Project Title:	Our Town Hall		
Project No:	1620003165		
Sketch No:	OTH-RAM-TH-LG-SKE-S-0020		
Title:	Lower Ground Floor Lintel Mark Up		
Status:	D2 - For Tender		
Scale:	NTS		
Eng:	Rev:	Date:	Checked:
MMG	T01	13/03/2020	CRS

OUR TOWN HALL PROJECT

PROJECT STATUS	STAGE 4
CLIENT	MANCHESTER CITY COUNCIL
PROJECT	OUR TOWN HALL PROJECT
DRAWING TITLE	LEVEL LG GENERAL ARRANGEMENT
SIZE & SCALE	A1: @1:200
DRAWING STATUS	D2 - TENDER
JOB NUMBER	1620003165
DRAWING NO.	OTH-RAM-TH-LG-DWG-S-1000 T02
REV

PLAN
1 : 200
LG LEVEL

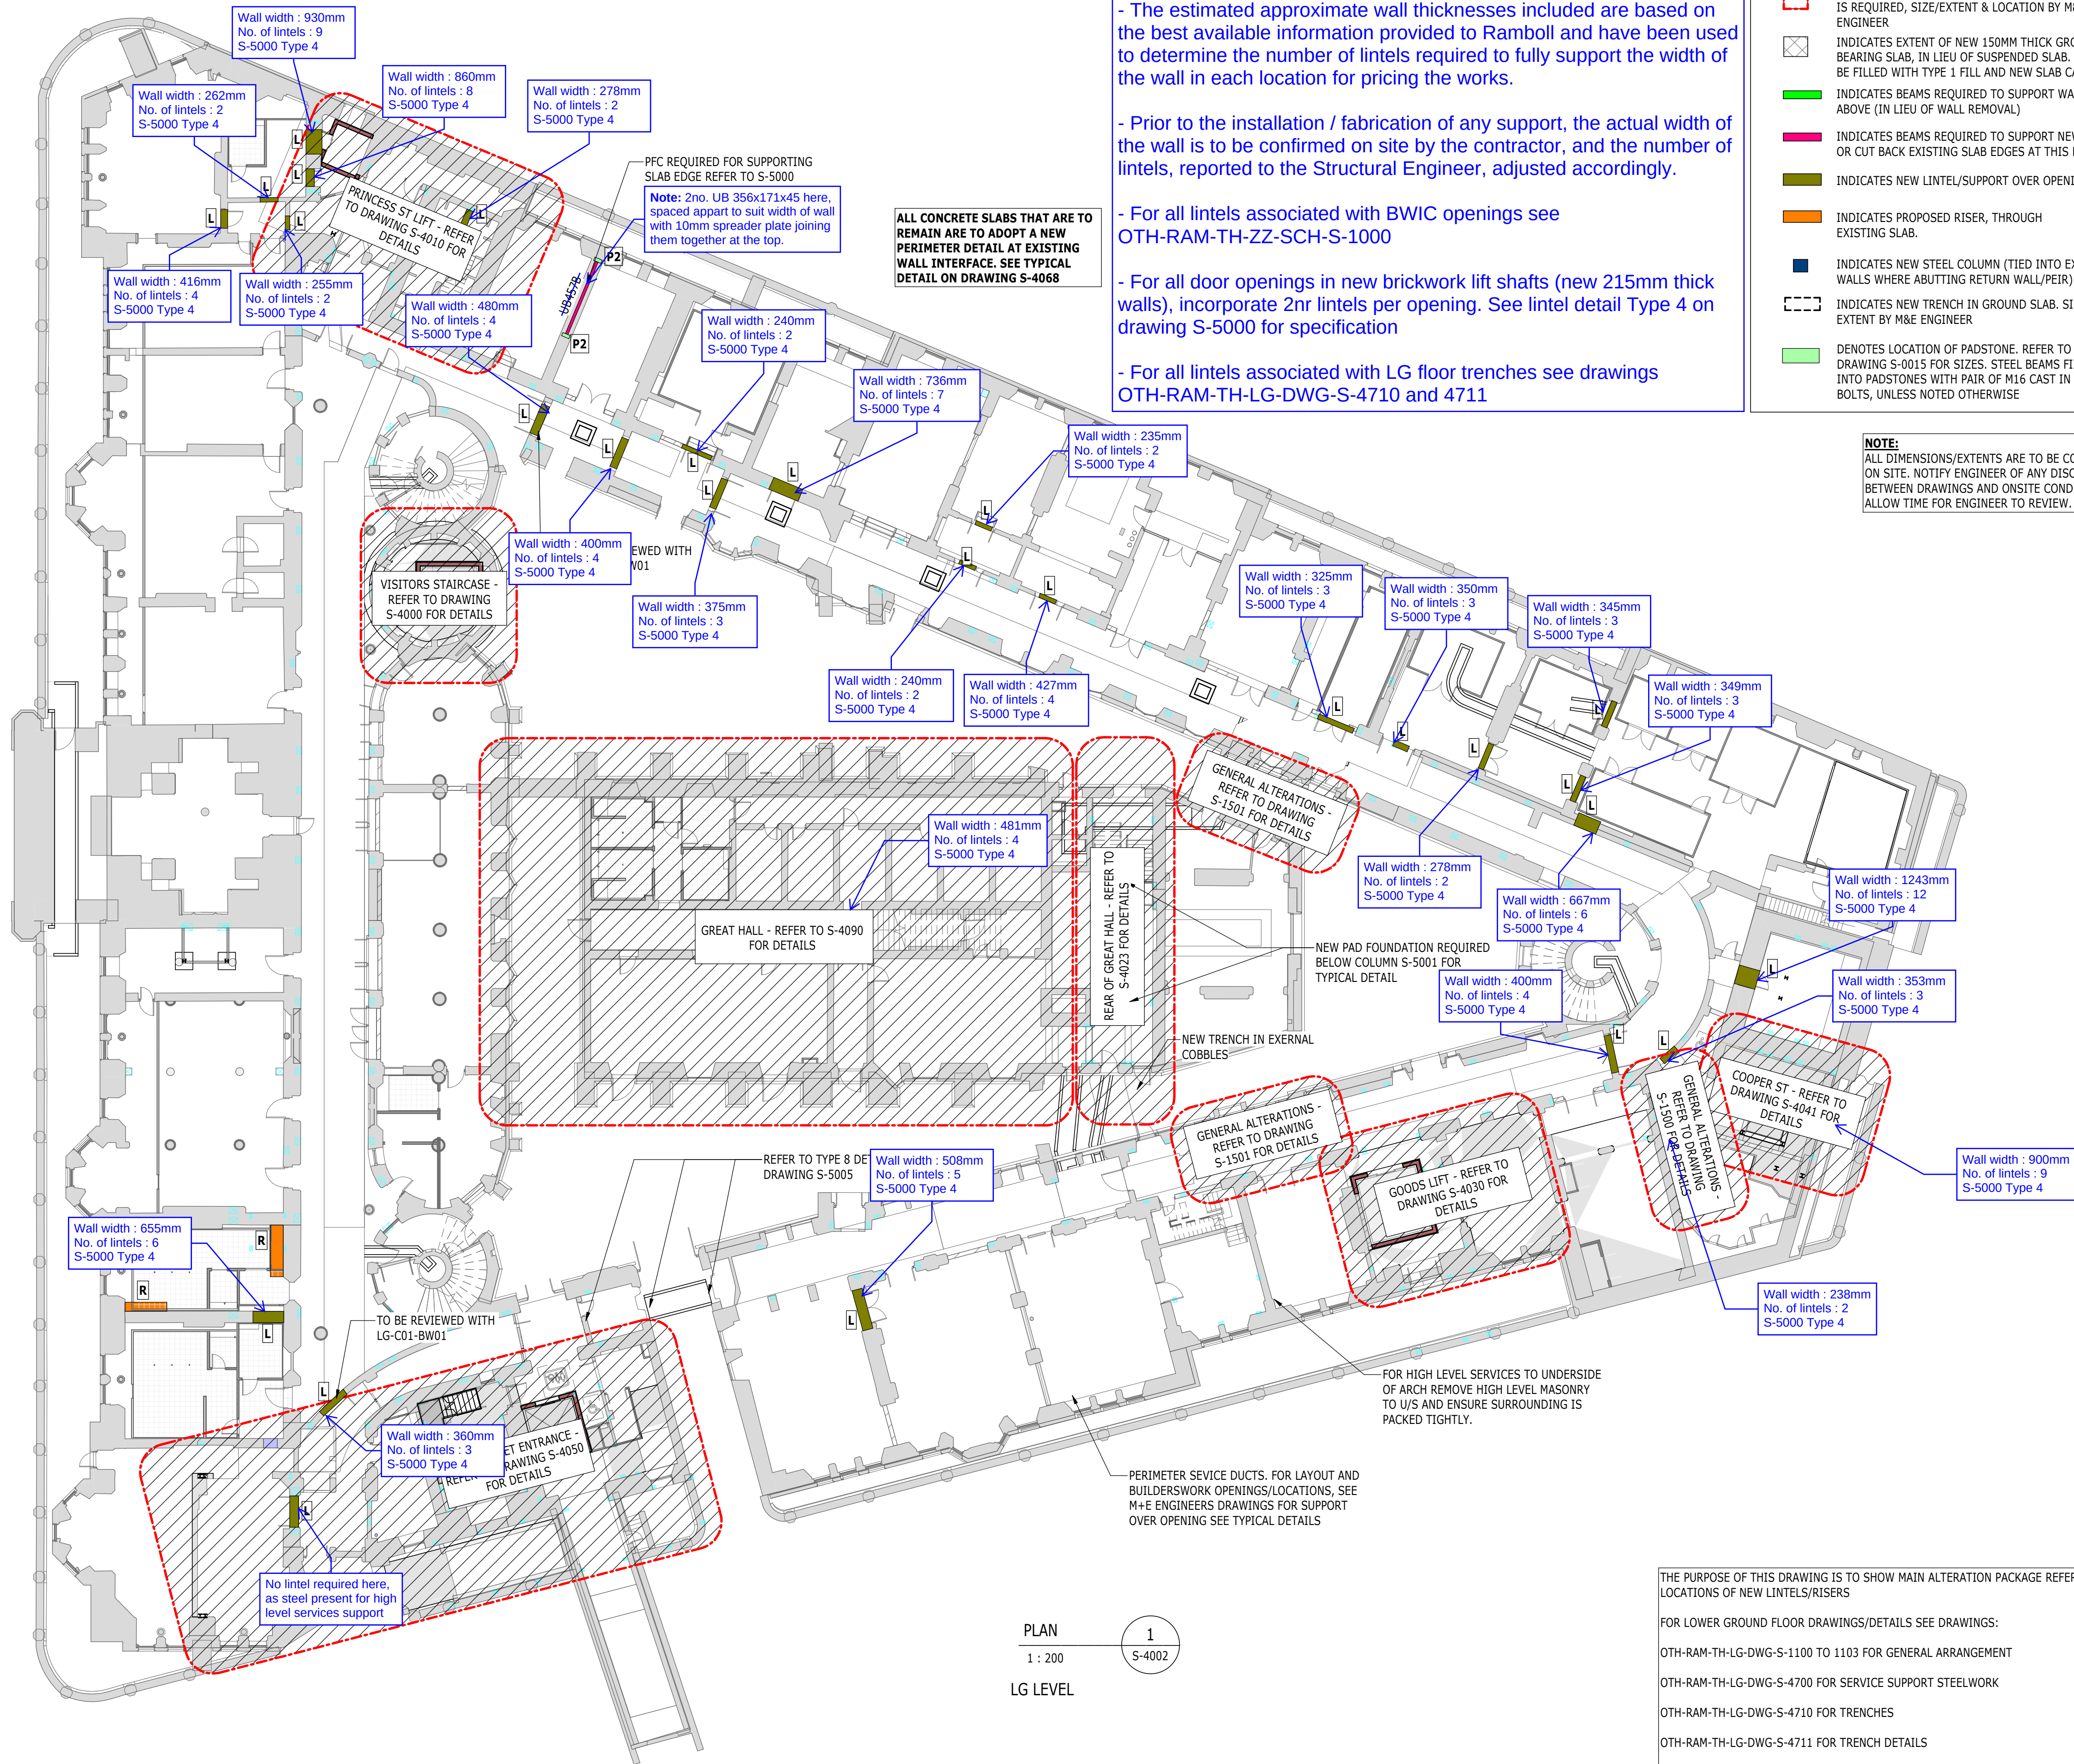
- This mark up is to assist with costing purposes for tender only.

- The estimated approximate wall thicknesses included are based on the best available information provided to Ramboll and have been used to determine the number of lintels required to fully support the width of the wall in each location for pricing the works.

- Prior to the installation / fabrication of any support, the actual width of the wall is to be confirmed on site by the contractor, and the number of lintels, reported to the Structural Engineer, adjusted accordingly.

- For all door openings in new brickwork lift shafts (new 215mm thick walls), incorporate 2nr lintels per opening. See lintel detail Type 4 on drawing S-5000 for specification
